YARRA CITY COUNCIL

Internal Development Approvals Committee

1.1 PLN17/0448 - 484 - 486 Swan Street Richmond - Use and development of the land for the construction of a mixed-use building (14 storey plus three basement levels), including offices, a restricted retail premises and five food and drink tenancies premises (7am to 11pm, seven days per week - permit required use), reduction of car parking requirements and buildings and works including alteration to access to a Road Zone (Category 1).

1. This report provides Council with an assessment of planning permit application No. PLN17/0448 which affects land at 484-486 Swan Street Richmond.

Attachment 3 - PLN17/0448-03 - 484 - 486 Swan Street Richmond - decision plans - basements 2 & 3 - idac attachment

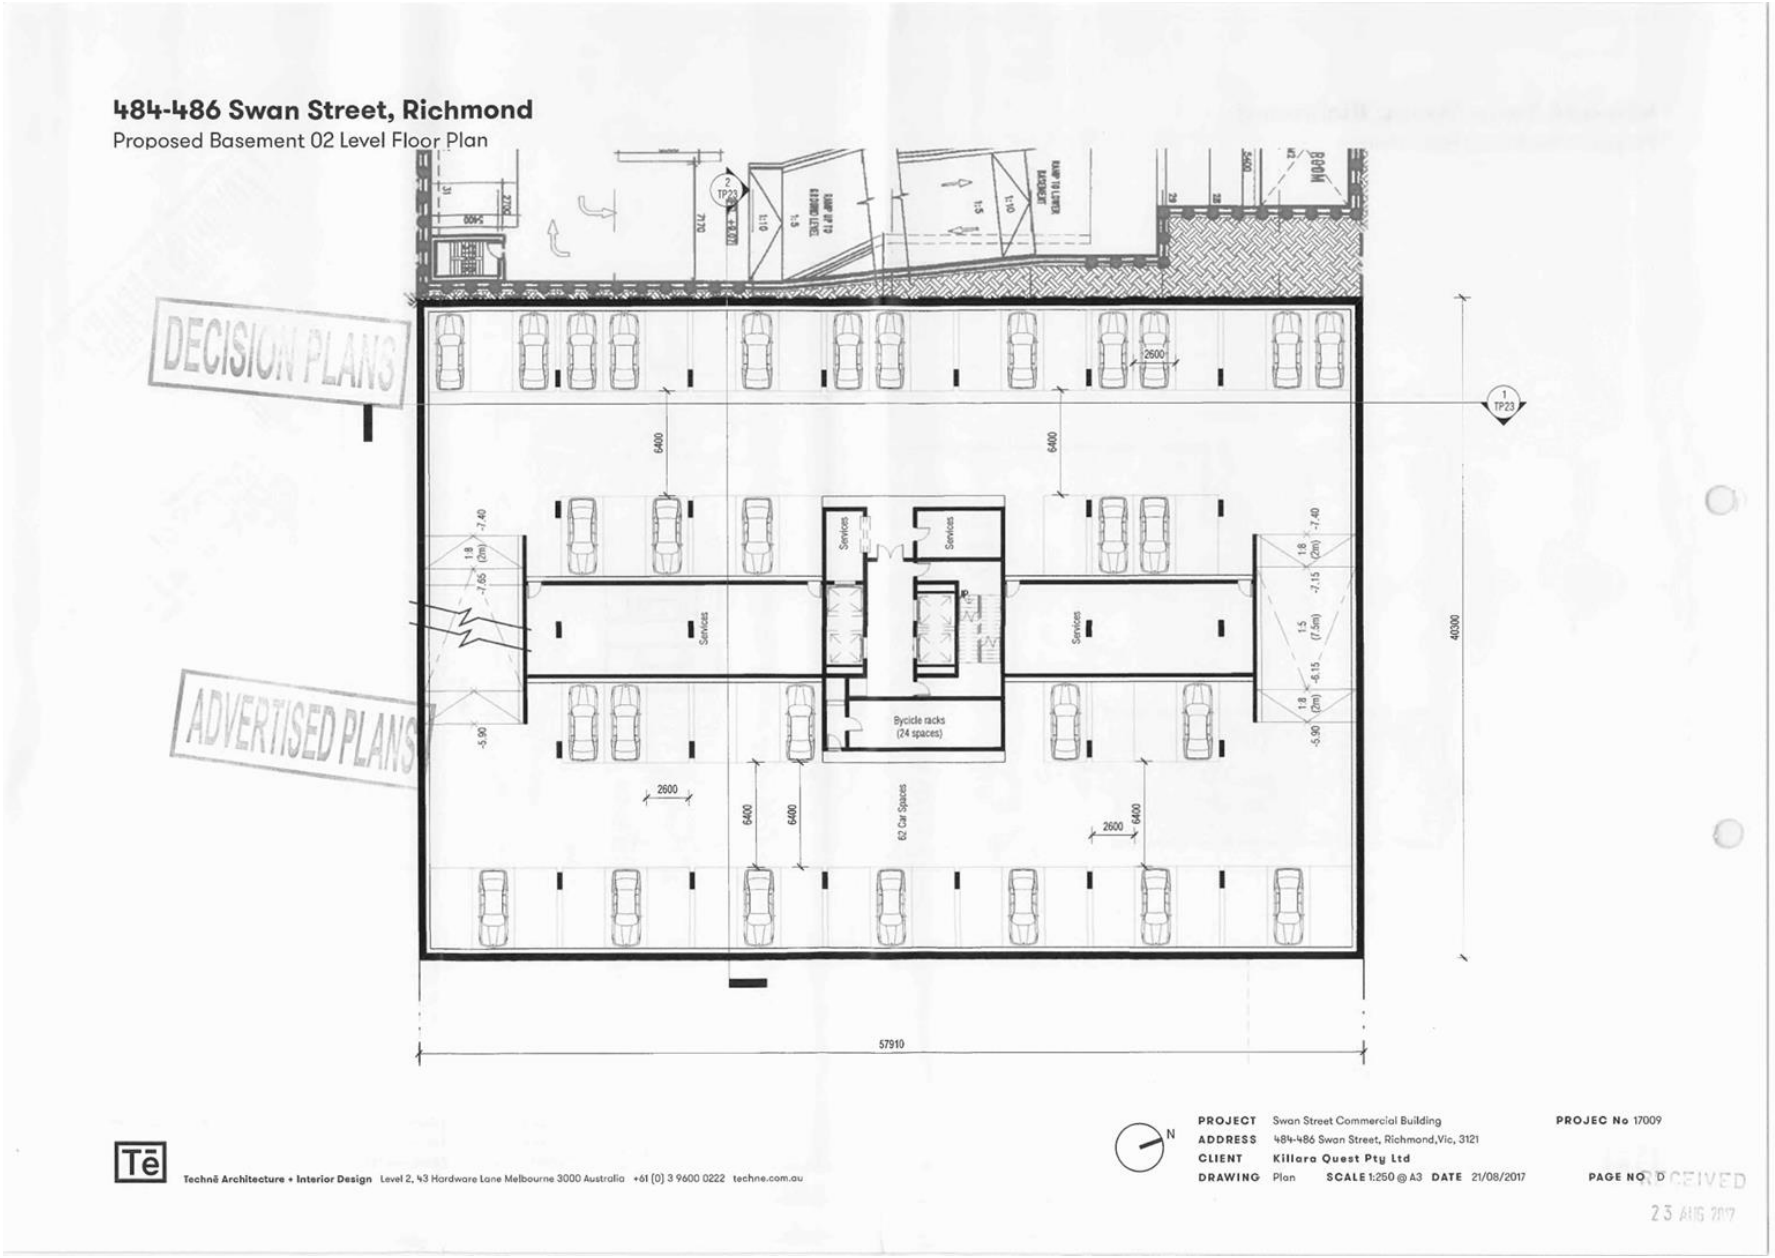
5. It should be noted that there are inconsistencies in the floor plans, where one set does not include Basement 03 whilst the other set shows Basement 02 and 03 on one plan. The sections also clearly show there are three basement levels. This will be required can be required to be rectified by a permit condition. This issue also highlights that the plans do not have plan page numbers (eg Drawing No. or TP are typically used), this will also be required by way of condition as it allows for easier referencing of plans.

Proposed Roof Plan

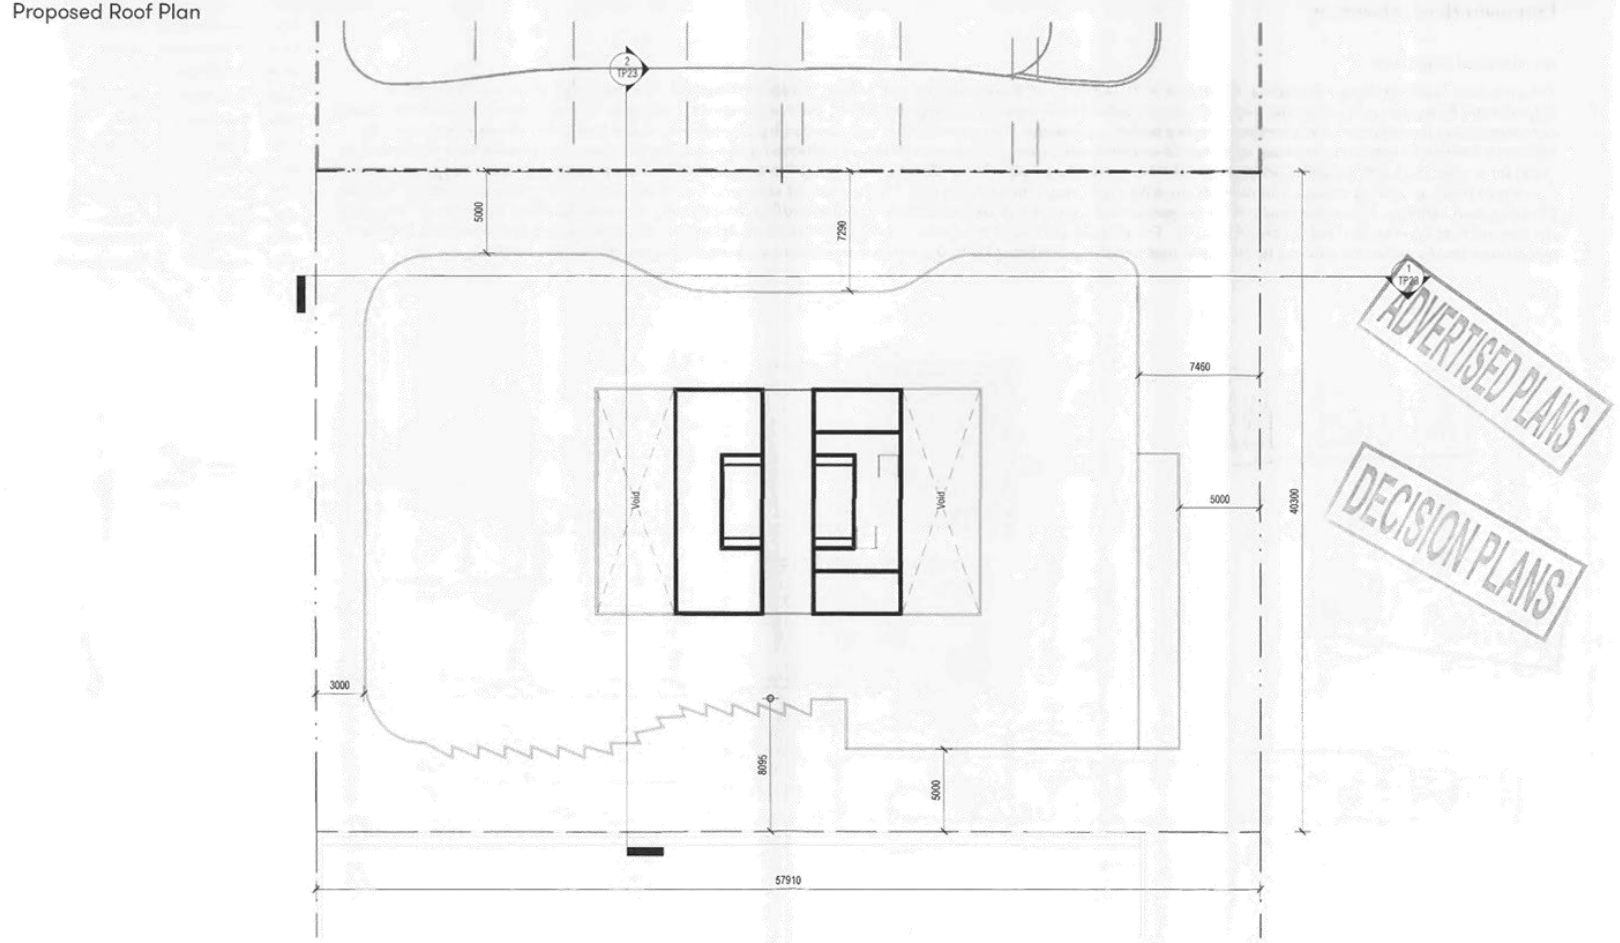
(t) The roof plan does not show any services, and this can be required by way of condition.

Attachment 8 - PLN17/0448-03 - 484 - 486 Swan Street Richmond - updated ground floor plan showing crossover - sketch plan

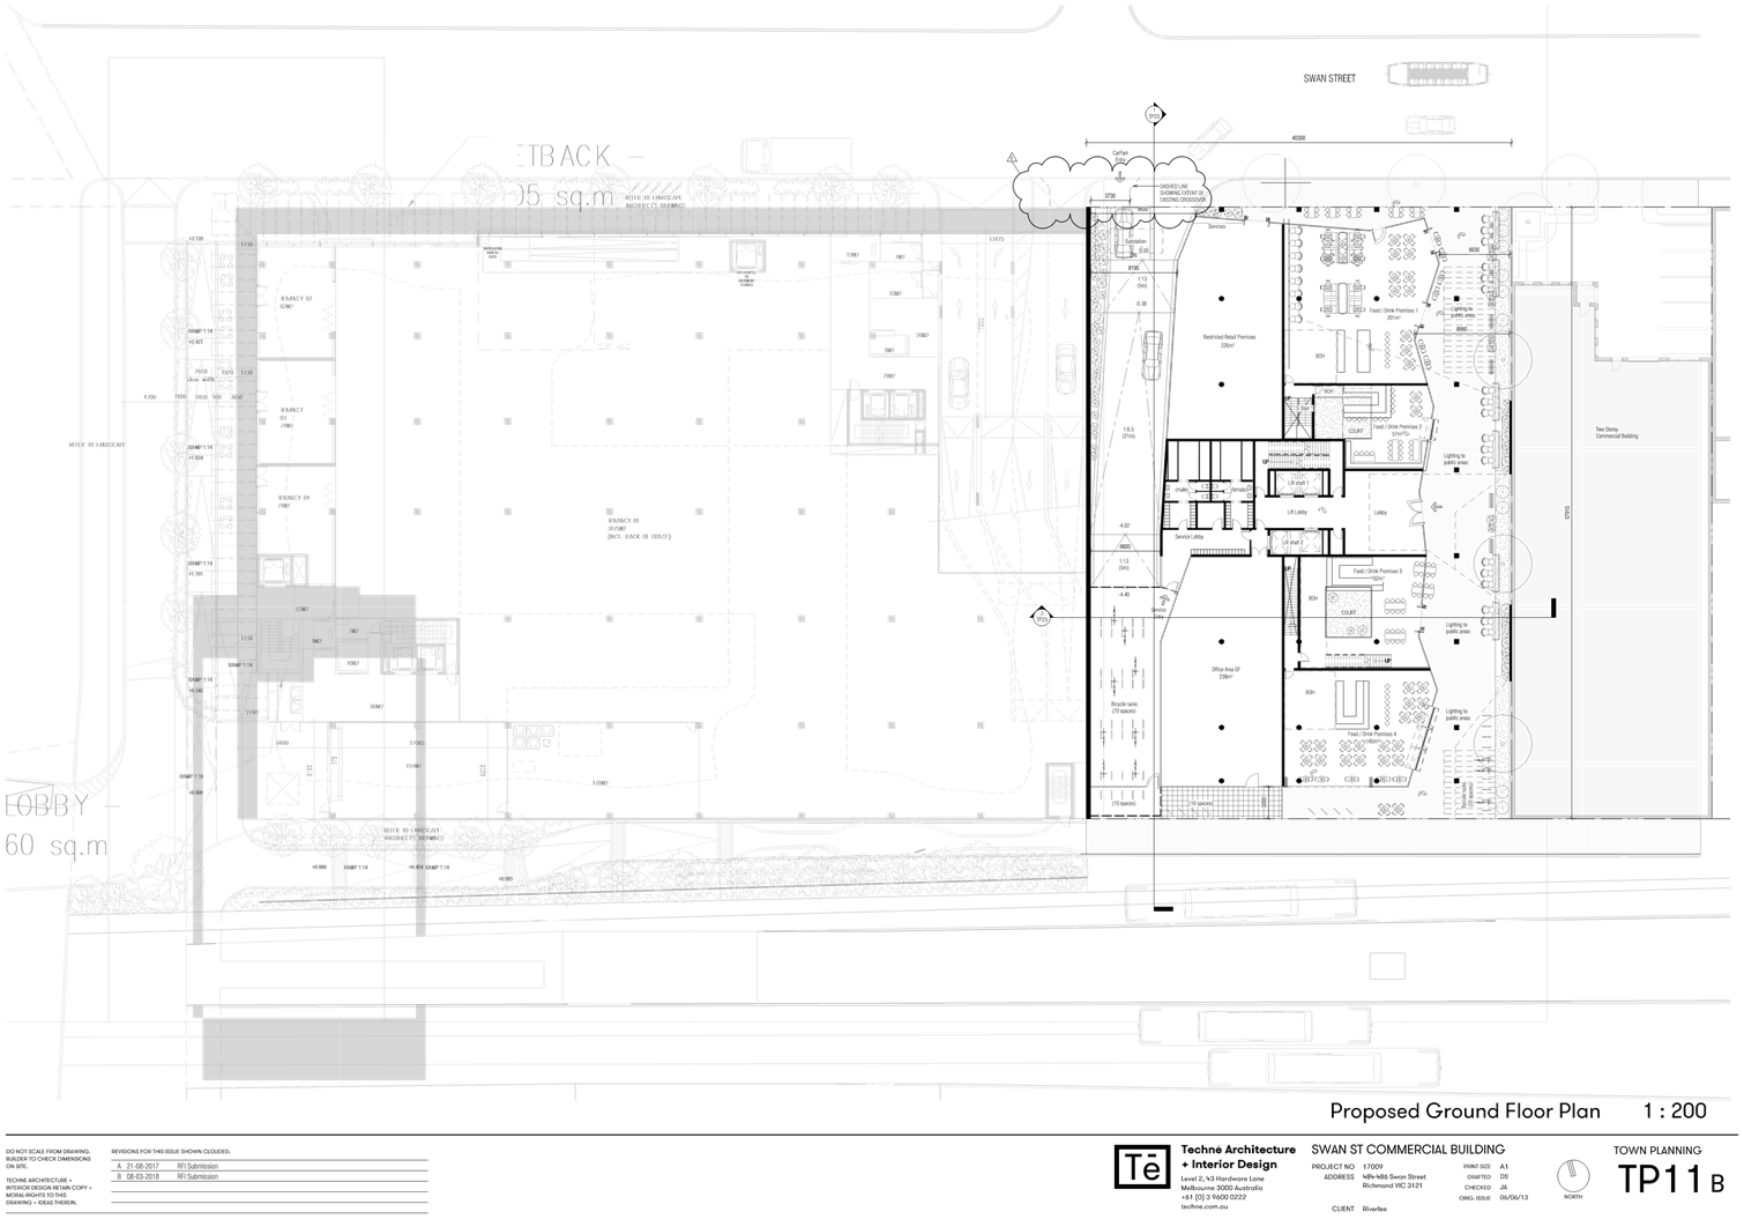
37. The proposal includes works to widen the existing crossover onto Swan Street. Swan Street is categorised as a Road Zone, Category 1. Pursuant to Clause 36.04-2, a planning permit is required to construct a building or construct or carry out works for a use in Section 2 of Clause 36.04-1. The proposed uses are not listed in Section 1 or 3 and are therefore a Section 2 use (permit required). The views of the relevant road authority are part of the decision guidelines for this zone.

52. Swan Street is a Road Zone, Category 1 and the application proposes to widen the existing crossover, therefore, a planning permit is required for the works.
